THE FOURTH MEETING OF THE MUNICIPAL HERITAGE COMMITTEE

May 13, 2026

SUBJECT: Heritage Alteration Permit
472 Talbot Street – Corrected Addressed (Previously identified at 572 Talbot Street)
HAP-07-26

SUBJECT: Heritage Alteration Permit
600 Talbot Street
HAP-08-26

Drawing No.
SCOT-CL030932.120A1

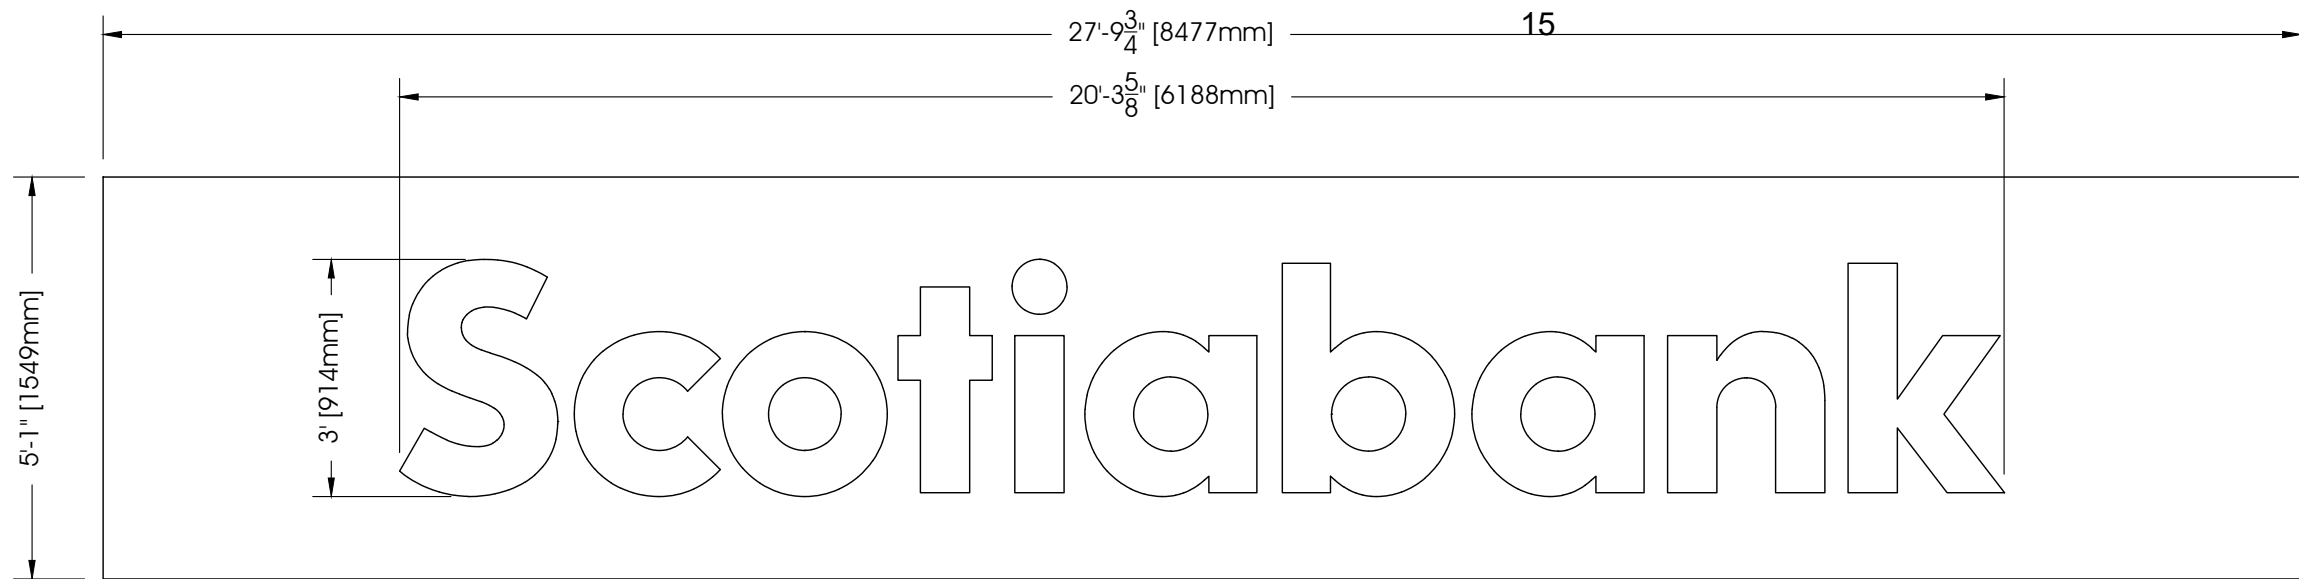
Staff have reviewed the application and are of the opinion that the proposal conforms to the policies and guidelines of the HCD Plan as the proposal would be a replacement of an existing illuminated sign and would not be covering windows or important elements of the building façade that are not already covered. As such, a Heritage Alteration Permit for the proposed sign has been issued.

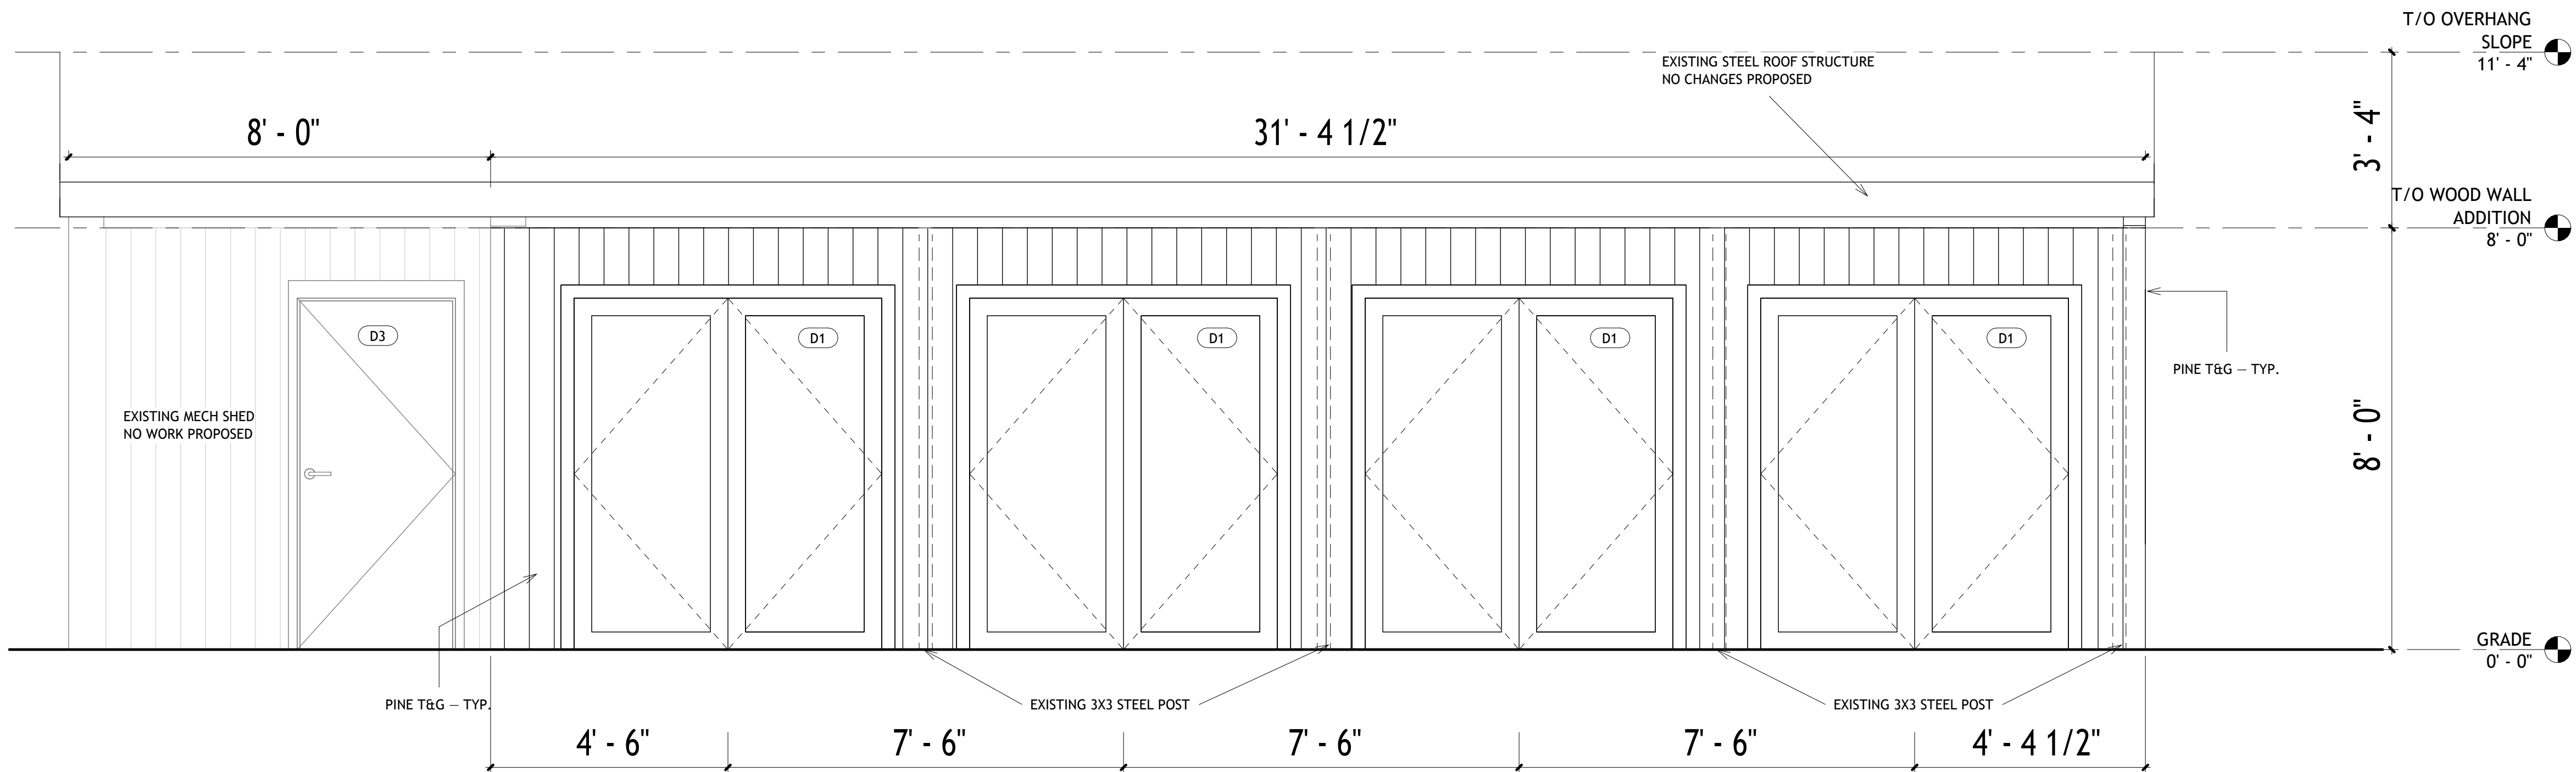
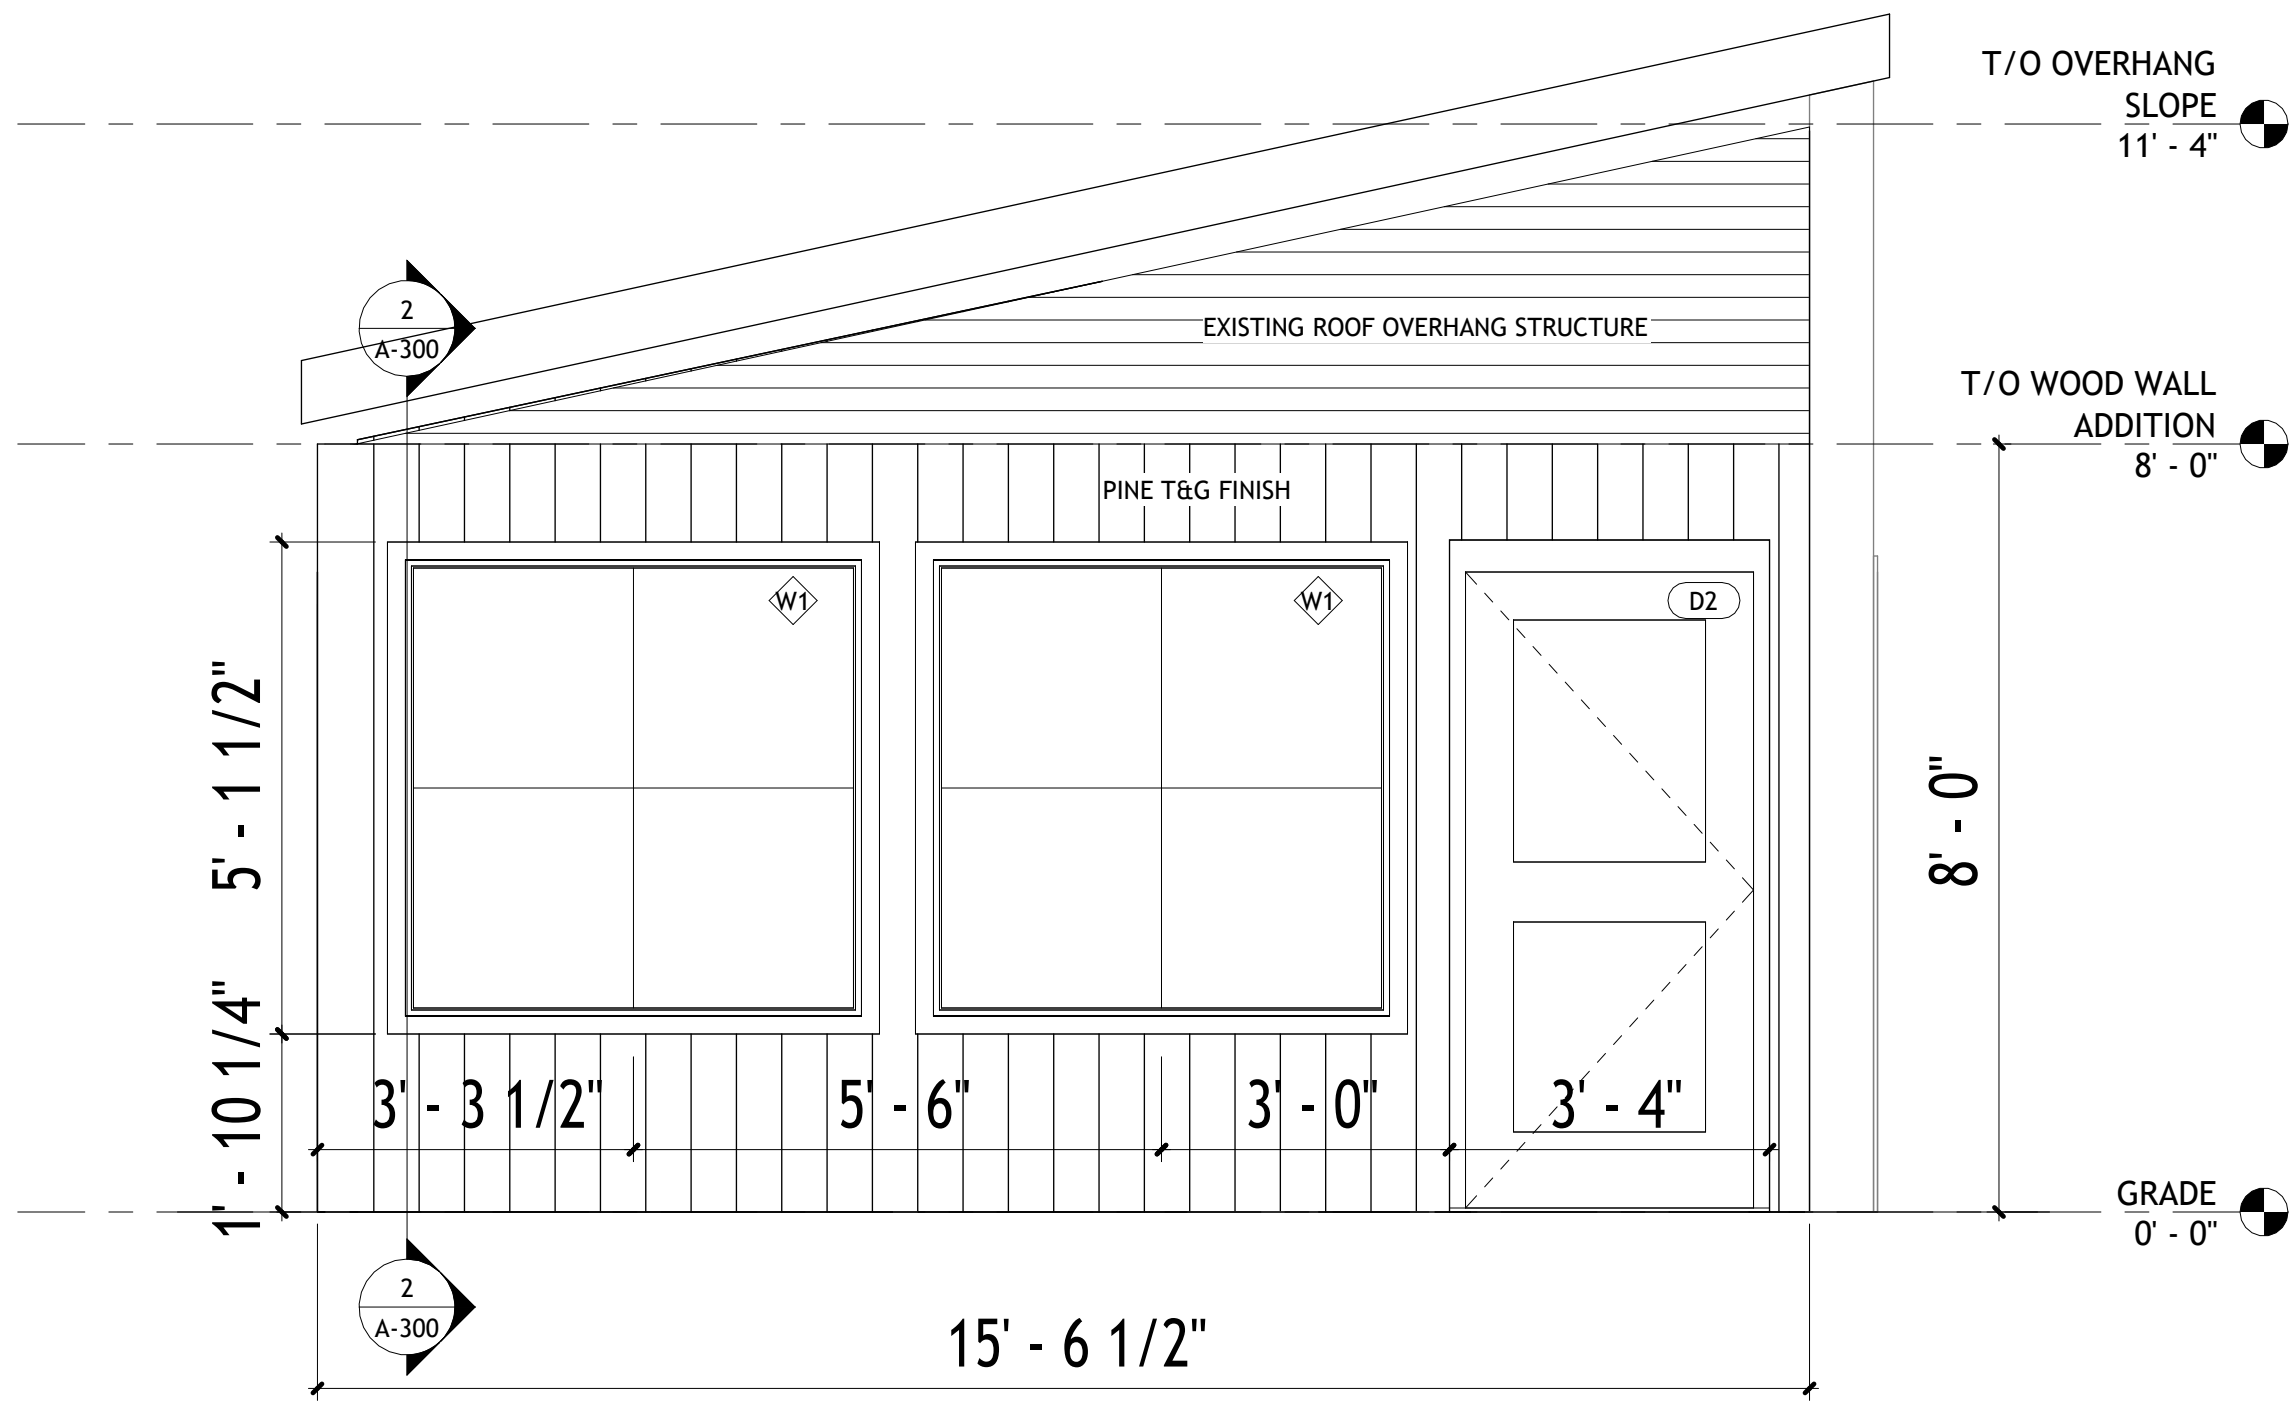
As shown in the supporting materials, the proposed addition would provide window and door openings on the façades that are visible to Talbot Street that would be complimentary or compatible with the existing building.

As noted in the Façade Patterns section of this memo, the Storefront section provides that the same glass to solid material proportions as in the surrounding HCD contributing resources should be maintained. As shown in the associated materials, the façade of the proposed enclosure will be utilizing an extensive amount of glazing, in addition to the proposed wood façade materials.
